January 13, 2011

Subject: NRC RAI dated March 10, 2010, Certificate of Compliance No. 9263

ADDITIONAL INFORMATION PER NRC REQUEST FOR SPEC-150, CERTIFICATE 9263

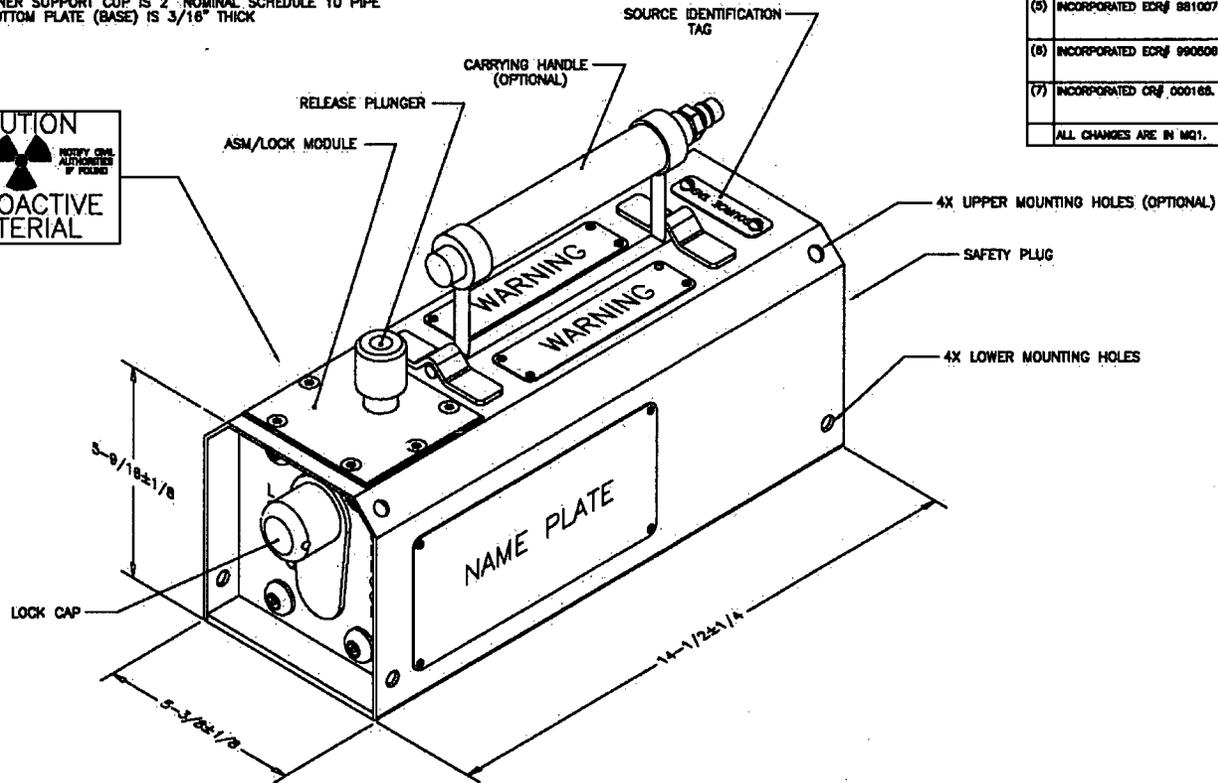
RAI	SPEC's Position / Response
<p>1 Specify which joints are structural and which are non-structural on the licensing drawings. The licensing drawings should unambiguously describe the welds on the package.</p>	<p>Drawing 15B000 contained notes describing the welding and inspection for "structural joints". These notes were removed from 15B000, and added to drawing 15B002A which depicts both Important to Safety (ITS) and non-ITS welds. The welding and inspection specifications for each weld are described on the drawing with arrows pointing to each weld. See Appendix A for revised drawings.</p>
<p>2 Clarify why internal structural joints do not undergo dye-penetrant testing.</p>	<p>The internal welds are not ITS welds. The internal welds are not 360 degree welds, they don't attach the bulkheads to the housing all the way around, the outer bulkhead welds do. They function as a construction aid by holding the internal components in position for the external 360 degree welds. Therefore, the primary reason to perform a visual weld inspection of the internal welds is to detect warpage, misalignments, adverse affects on the base weld material, improper fit up, and other unacceptable weld attributes. The outer 360 degree welds that attach the bulkheads to the housing are dye penetrant tested.</p>

Drawing	Rev	Description of Changes from Current Certificate
15B000	8	Removed fabrication and inspection notes, they are now described on 15B002A. Added supplemental shielding note from 15B008 rev 5, added maximum weight and materials from 15B002A rev 6. Added note to see SAR for material specifications.
15B002A	7	Added fabrication and inspection notes for ITS and non-ITS welds, added material specifications for safety related components.
15B008	6	Removed notes that did not specifically describe the depleted uranium shield. Added minimum weight and density.
19B005	1	Added material specifications for safety related components, the source assembly lock, device lock, lock module housing and lock module faceplate.
19B006	1	Added material specifications for safety related components, the source assembly lock and device lock.
(190909)	(0)	(No changes needed, original drawing was not replaced and is not appended.)

- SUPPLEMENTAL SHIELDING, IF NEEDED TO MEET NORMAL CONDITION DOSE RATE LIMITS, IS ATTACHED TO THE SHIELD OR OTHER PACKAGE COMPONENTS USING ALUMINUM EPOXY POTTING COMPOUND. THE SUPPLEMENTAL SHIELDING CONSISTS OF ONE POUND OR LESS OF DEPLETED URANIUM, TUNGSTEN OR LEAD.
- MAXIMUM WEIGHT: 53.5 LBS.
- SEE SAR FOR MATERIAL SPECIFICATIONS  
HOUSING COVER IS 3/32" THICK  
OUTLET END SUPPORT CUP & BULKHEADS ARE 1/8" THICK  
INNER SUPPORT CUP IS 2" NOMINAL SCHEDULE 10 PIPE  
BOTTOM PLATE (BASE) IS 3/16" THICK

SOURCE PRODUCTION & EQUIPMENT CO., INC. 113 TEAL ST. ST ROSE, LA 70087	
APPROVALS	DATE
DESIGNED BY: KP	1-07-11
DRAWN BY: MQ1	M C 1
CHECKED BY: MQ1	M C 1
DATE: 11-08	7
SCALE: NTS	00062707 SHEET 1 OF 1

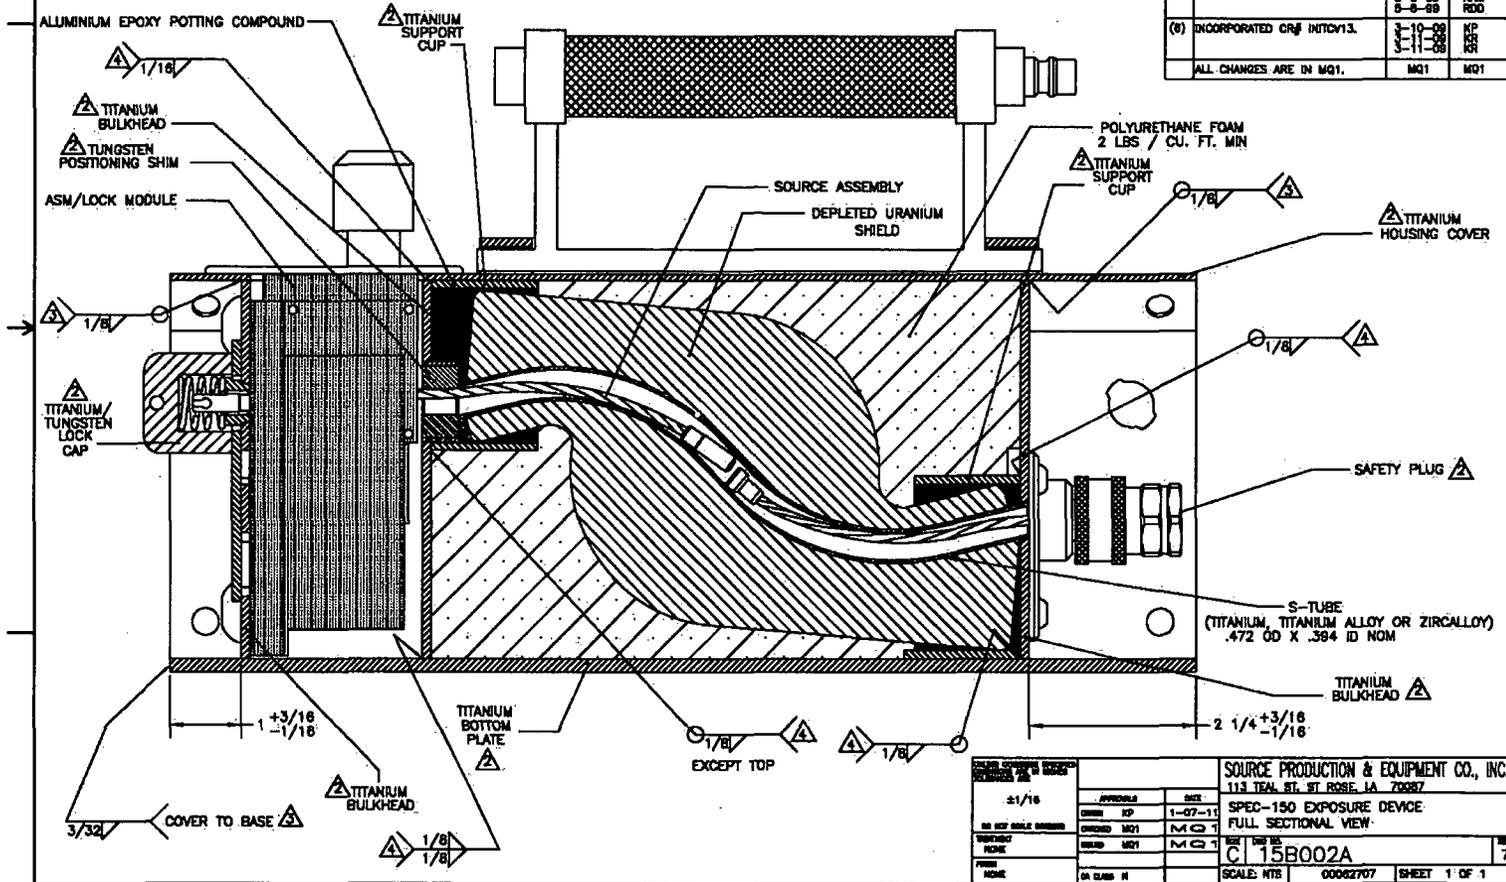
<p>3 Citing a standard industrial code, specify that all thermal metal joints will be examined. State the examination methodologies and the acceptance criteria used in the weld fabrication by citing a standard industrial code.</p>	<p>Drawing 15B002A was revised to point to each specific weld and specify the corresponding inspection method depending on whether the weld is important to safety. Drawing notes were added as follows: - This important to safety (ITS) weld is fabricated and liquid penetrant inspected in accordance with ASME Section VIII, Division I, or, fabricated and inspected in accordance with AWS D1.9. - This weld is not ITS, and is fabricated and visually inspected in accordance with ASME Section VIII, Division I, or, fabricated and visually inspected in accordance with AWS D1.9. See Appendix A for revised drawings.</p>
<p>3 Ensure that Section 8.1.2 of the application is consistent with the licensing drawings.</p>	<p>Section 8.1.2 was revised to be consistent with the above RAI response. See Appendix C: Revised page 73.</p>

<p>4 Specify ASME code of construction (e.g., Section VIII, Division I) which is used as the basis for welding for thermal metal joints on the package.</p>	<p>Welds are performed in accordance with the applicable requirements of ASME Section VIII, Division I using procedures and welders qualified in accordance with ASME Section IX. We plan to transition both fabrication and welding to the AWS code later. See Appendix A for revised drawings.</p>

RAI	SPEC's Position / Response
5	Clarify why the ASTM E-165 is used as the basis for the examination procedures of thermal metal joins on the package, and not Section V of the ASME code.	The statement on drawing 15B002A has been revised to state that dye penetrant weld examinations are performed in accordance with ASME Section VIII, Division I. ASME Section V, Article 24 covers Liquid Penetrant Standards, and includes SE-165 (which states that it is identical to ASTM E 165).
6	Specify a standard industrial code, e.g., ASTM or ASME, which mandates the minimum mechanical properties and level of fabrication quality for all materials used to construct components that are safety-related, with the exception of zirconium and depleted uranium alloys.	The drawings were revised by adding a note stating "See SAR for Material Specification". We have included an Appendix to Section 5.0 of the SAR listing the material specifications for materials related to package safety, with the exception of zirconium and depleted uranium alloys. The depleted uranium shields are surveyed to ensure that they shield properly. They are described in the drawings as being at least 99% pure, with a minimum density of 18.3 g/cc, and weight of 35 to 37 1/4 pounds. See Appendix A for revised drawings and Appendix D for material specifications.

1. REMOVED.
- SEE SAR FOR MATERIAL SPECIFICATIONS.
- IMPORTANT TO SAFETY (ITS) WELDS ARE FABRICATED AND LIQUID PENETRANT INSPECTED IN ACCORDANCE WITH THE APPLICABLE REQUIREMENTS OF ASME SECTION VIII, DIVISION I, OR, FABRICATED AND INSPECTED IN ACCORDANCE WITH AWS D1.9.
- THIS WELD IS NOT ITS, AND IS FABRICATED AND VISUALLY INSPECTED IN ACCORDANCE WITH ASME SECTION VIII, DIVISION I, OR, FABRICATED AND VISUALLY INSPECTED IN ACCORDANCE WITH AWS D1.9.

SOURCE PRODUCTION & EQUIPMENT CO., INC. 113 TERL. ST. ST. ROSE, LA. 70087	
SPEC-180 TYPE (K) PACKAGE DEPLETED URANIUM SHIELD	
PROJECT NO. 158008	REV. NO. MO1
DATE 1-28-11	SCALE N/A
BY C/158008	DATE 6
SCALE: NTS	00022806 SHEET 1 OF 1

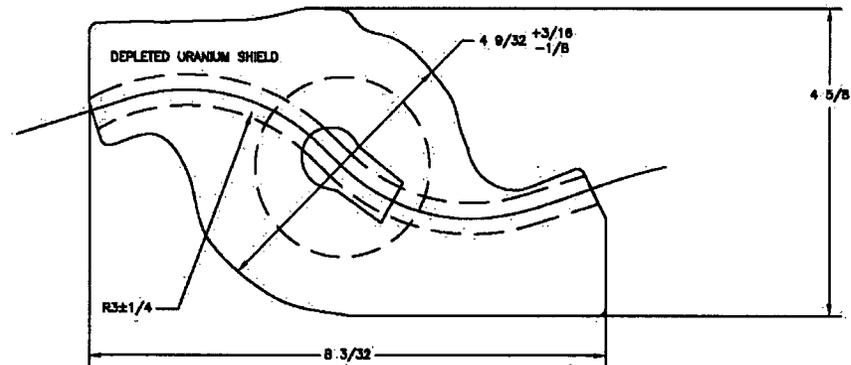
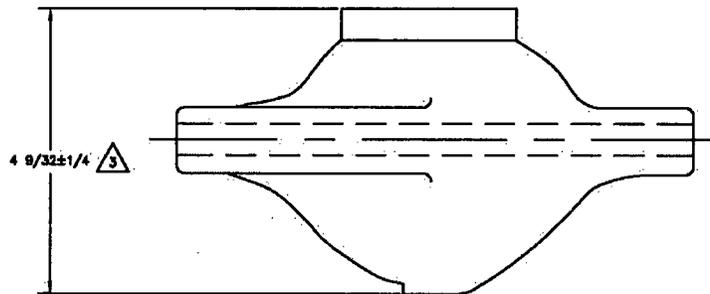
10	Specify a minimum weight and density for the depleted uranium shield on sheet 1 of drawing B150008. Needed to determine compliance with 10 CFR 71.31(a)(5)(iii) ("internal and external structures supporting or protecting receptacles").	Drawing 15B008 has been revised to add a minimum density of 18.3g/cc and a minimum weight of 34 pounds. As these requirements are new, they are not applicable to SPEC-150 shields manufactured prior to the issue date of USA/9263/B(U)-96, revision 8. Shields manufactured prior to that date must continue to meet the conditions of revision 7 and prior package approvals, and are inspected and surveyed to verify acceptability. See Appendices A and D.

1. WEIGHT: 34 TO 37-1/4 LBS.
2. MATERIALS OF CONSTRUCTION:  
DEPLETED URANIUM, MINIMUM 99% PURE, DENSITY MINIMUM 18.3 g/cc.
